Subject: UniStar Nuclear Energy, NRC Docket No. 52-016
Calvert Cliffs Nuclear Power Plant, Unit 3
Follow-up Response to Requests for Additional Information
Nos. 1001-14 and 1008-6

**Follow-up Responses to NRC Requests for Additional Information
RAI No. 1001-14, ESRP 4.3.2-3, and RAI No. 1008-6, ESRP 4.3.2-6
Calvert Cliffs Nuclear Power Plant Unit 3**

RAI No. 1001-14

ESRP 4.3.2-3

Figure 3 Annotated
SITE PLAN @ UNIT 3 INTAKE
STRUCTURE - SHT 1

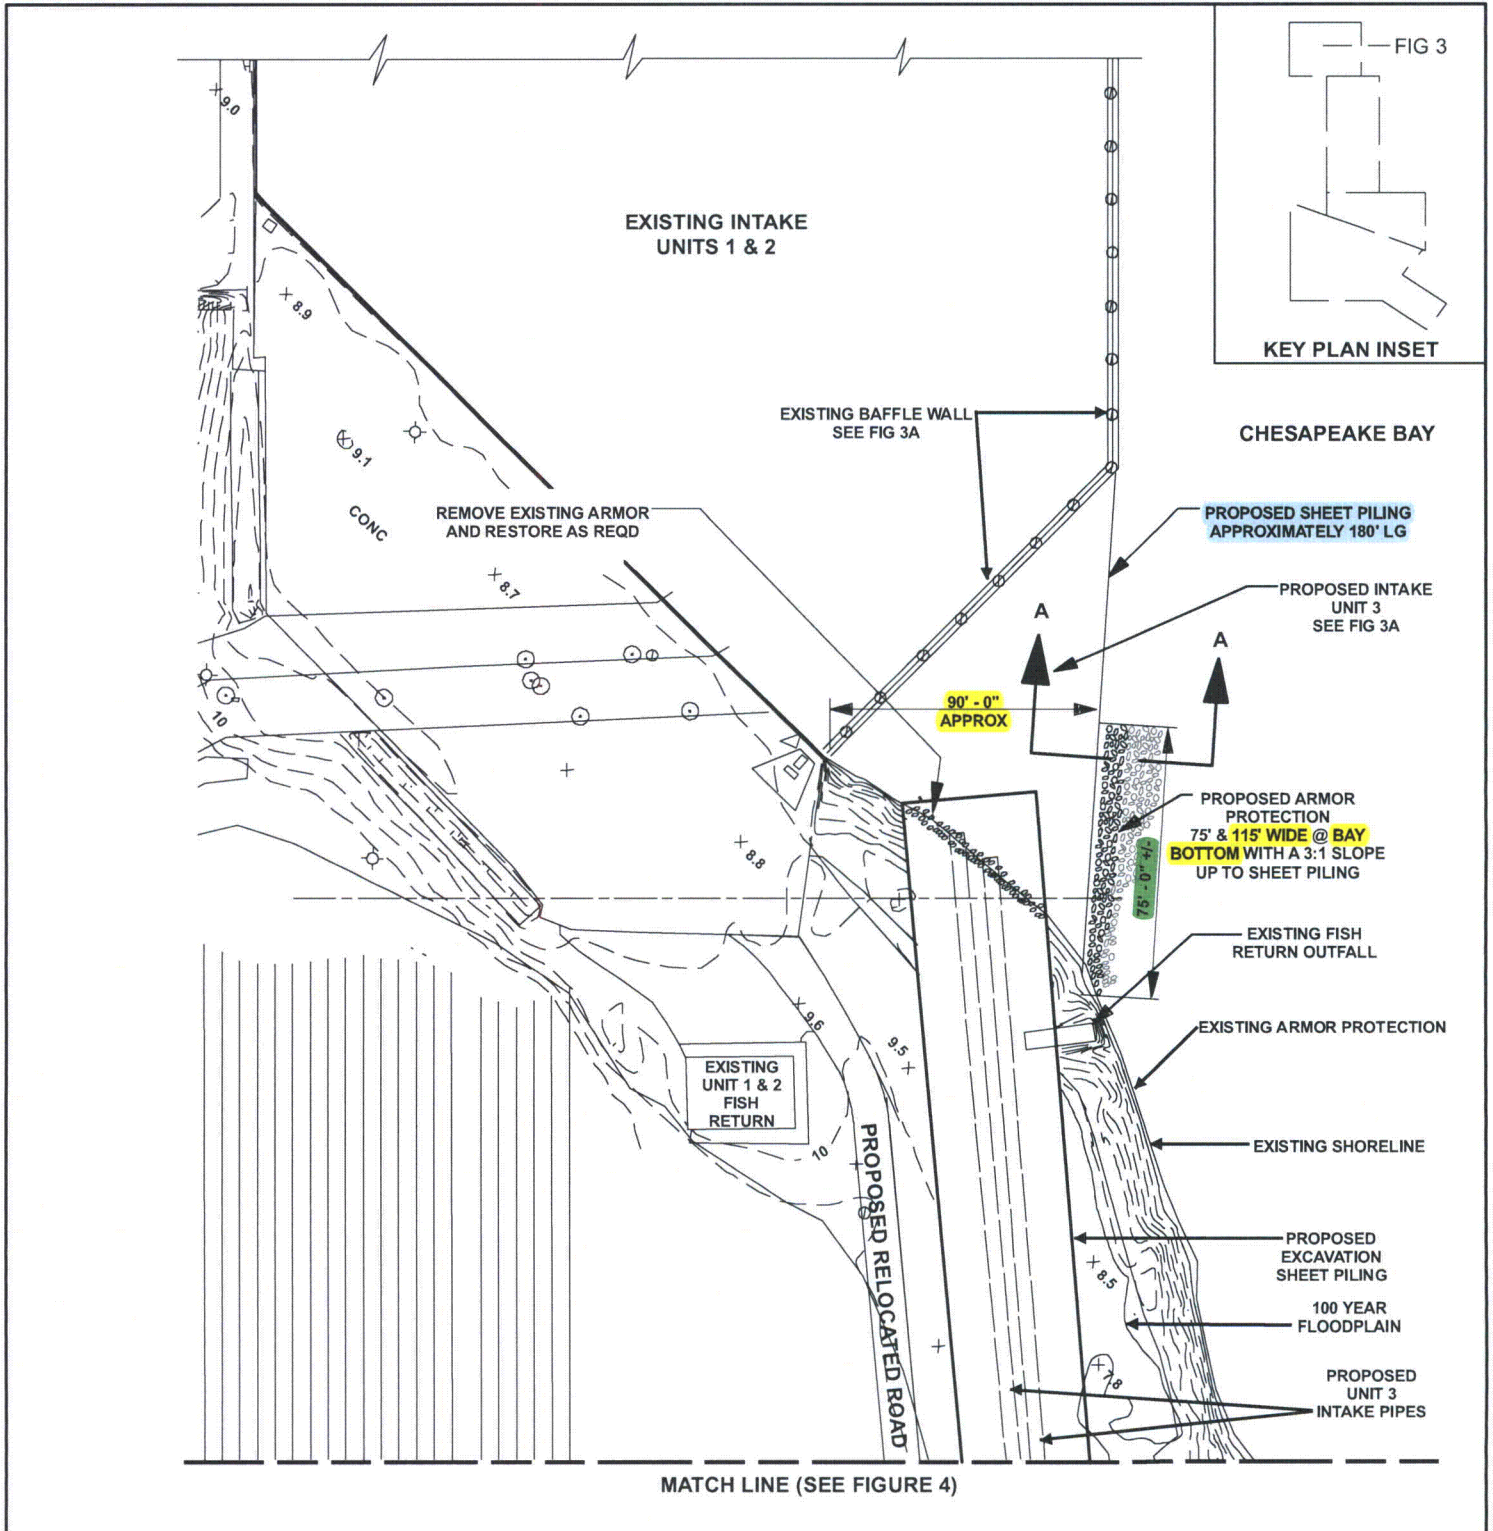
The September 29, 2008 RAI response to RAI #6 includes a Fig. 3A, which refers (within the figure) to Fig. 3B (Proposed Armor Protection—see Figure 3B for Extent of Protection), which was not found. Provide this or a new graphic that shows the bayward extent of the armoring that would be added to protect the new baffle wall installed for the intake system for proposed Unit 3.

Figure 3, "Site Plan @ Unit 3 Intake Structure - Sht 1", is the figure that shows the bayward extent of the armoring as 75'-0" +/- (an annotated copy of this figure showing this dimension highlighted in green is attached herein). This figure references Figure 3A, "Site Plan @ Unit 3 Intake Structure - Sht 2", which provides a more detailed view of the wedged-shaped pool intake structure proposed for Unit 3. This figure, in turn, references Figure 3B, "Proposed Armor Protection".

Figure 3A Annotated Bay Bottom
SITE PLAN @ UNIT 3 INTAKE
STRUCTURE - SHT 2

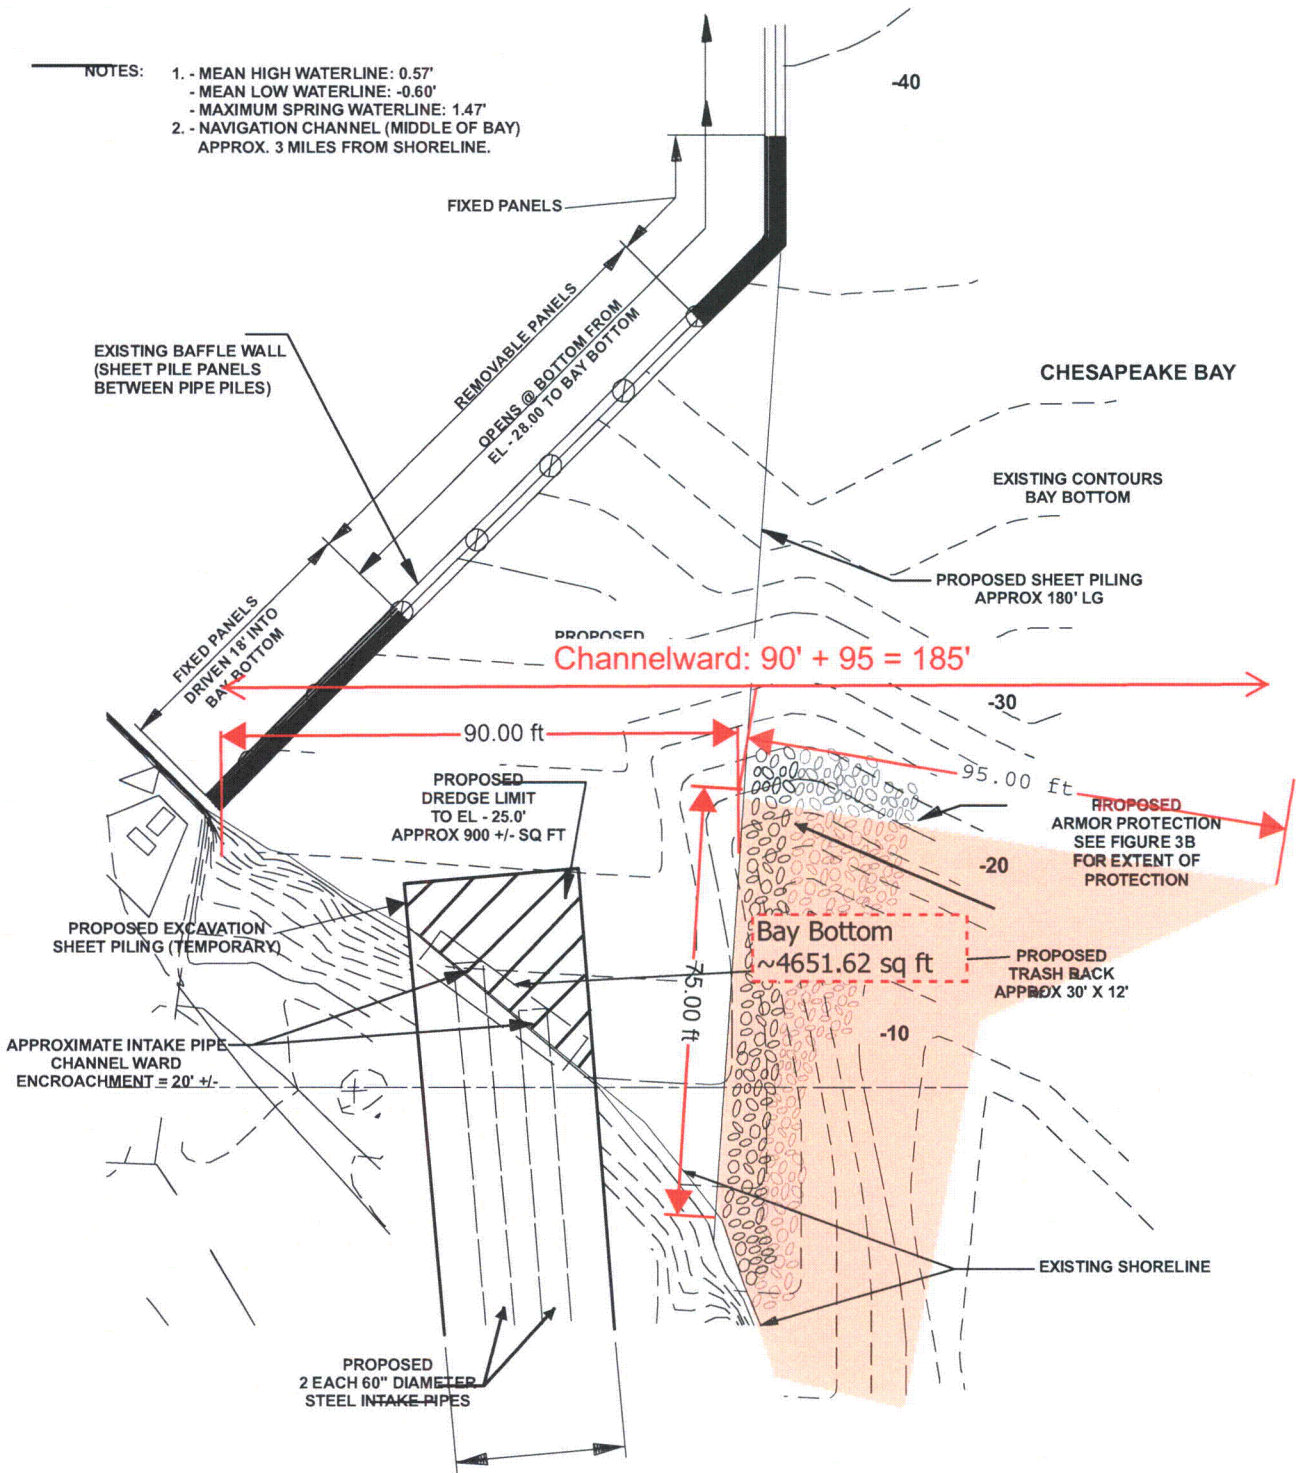
The NRC and its contractor have requested additional clarification regarding two items: 1) "Channelward" dimension of 205 feet described in the Joint Permit Application Work Description and 2) the actual footprint of the proposed armor protection on the bay floor. In response to this request, attached is an annotated copy of Figure 3A, "Site Plan @ Unit 3 Intake Structure - Sht 2" which graphically presents the responses and is explained as follows:

- 1) The term "Channelward" is an Army Corps term used to define an impact distance extending perpendicular to the existing shore to the furthest extent of tidal work and was identified as 215'. For this project it is the sum of the width of the "Proposed Intake Unit 3" and the footprint of the armor protection and the bay floor. These dimensions are "90'-0" APPROX" and "115' WIDE @ BAY BOTTOM" as identified in yellow highlight on the attached annotated Figure 3. It should be noted that based on further refinements in design to reduce impacts the 115' dimension has been updated/changed to 95' as shown in Figure 3B. As such, Figure 3A will be updated reflect this change. The attached annotated Figure 3A identifies the updated "Channelward" dimension as 185'.

- 2) The attached annotated Figure 3A shows that the "estimate" impact on the bay bottom by the armor protection is approximately 4650 sq ft. This "estimate" was derived graphically by assuming a hypothetical footprint of the armor protection bottom dimension utilizing the 3:1 ratio and the bay depth shown on the figure.

Actual impact on the bay bottom will be determined when the final detailed design is developed.

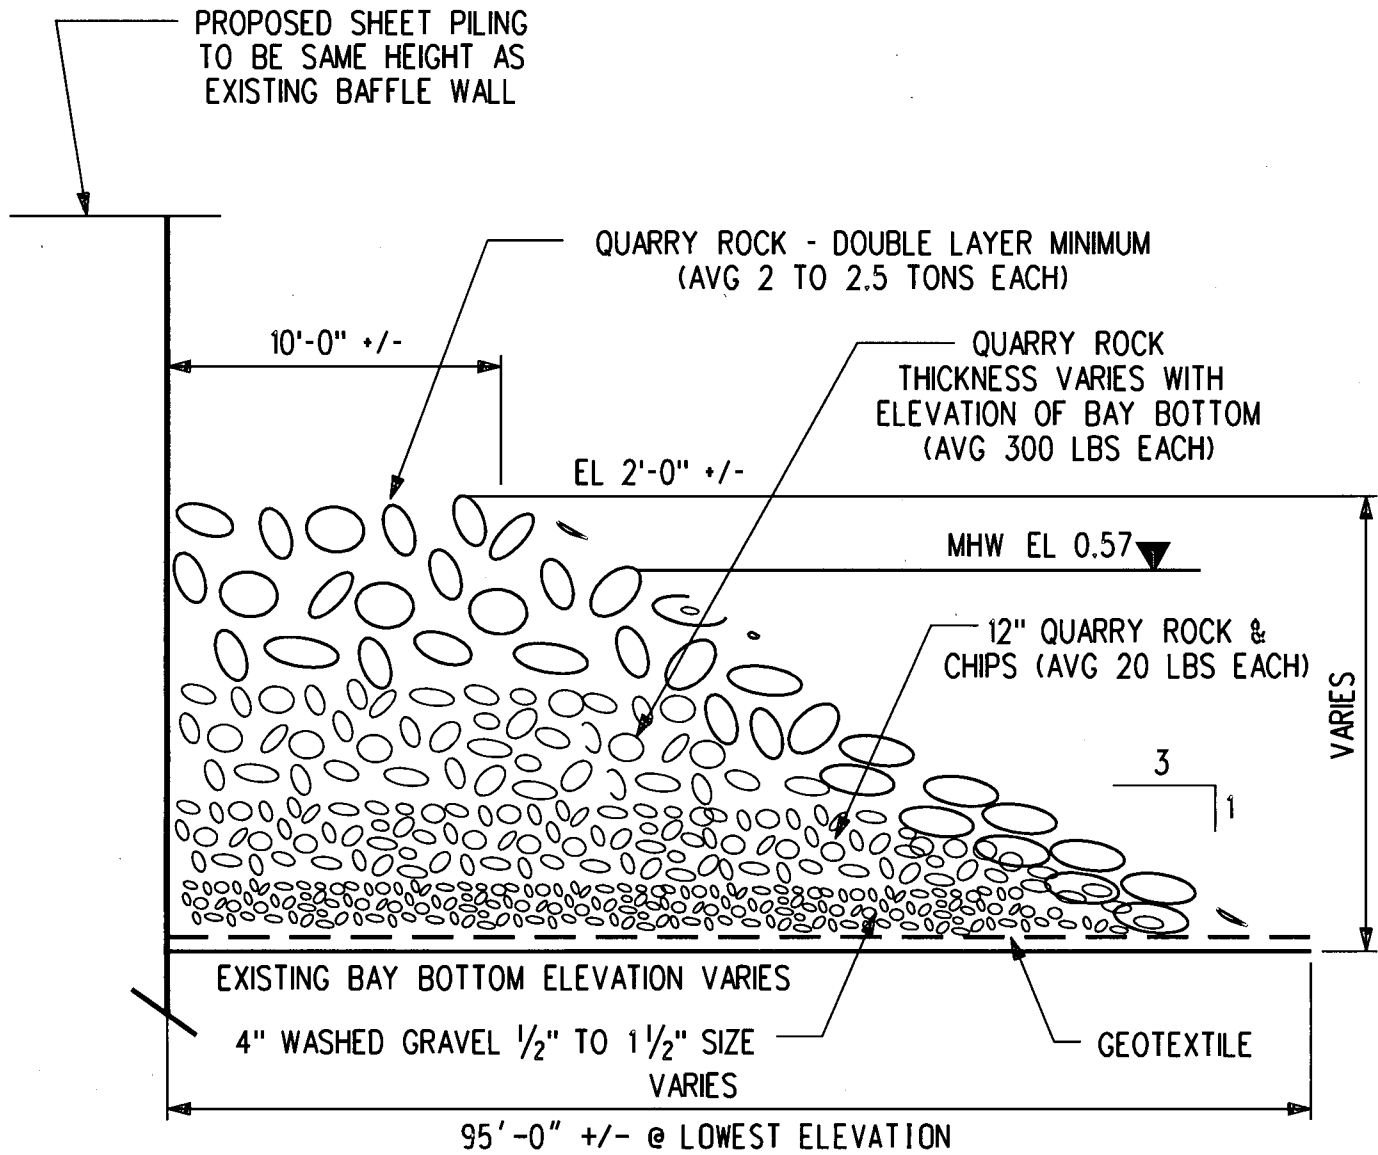
Provide a figure that shows the bayward extent of the armoring that would be added to protect the new baffle wall installed for the intake system for proposed Unit 3. This is Figure 3B, which was not included in the September 29, 2008 RAI response. The figure should fit on one 8.5" x 11" page.

Attached is the requested Figure 3B, "Proposed Armor Protection". Figure 3B shows a cross section of the proposed armor protection. This figure identifies the 3:1 ratio of rise to run (i.e., depth to width of armor protection at the bay bottom) with a maximum bay bottom width of 95' - 0" +/- @ lowest elevation.

UniStar response to RAI 1001-14 (ESRP 4.3.2-3) provides the requested figure.
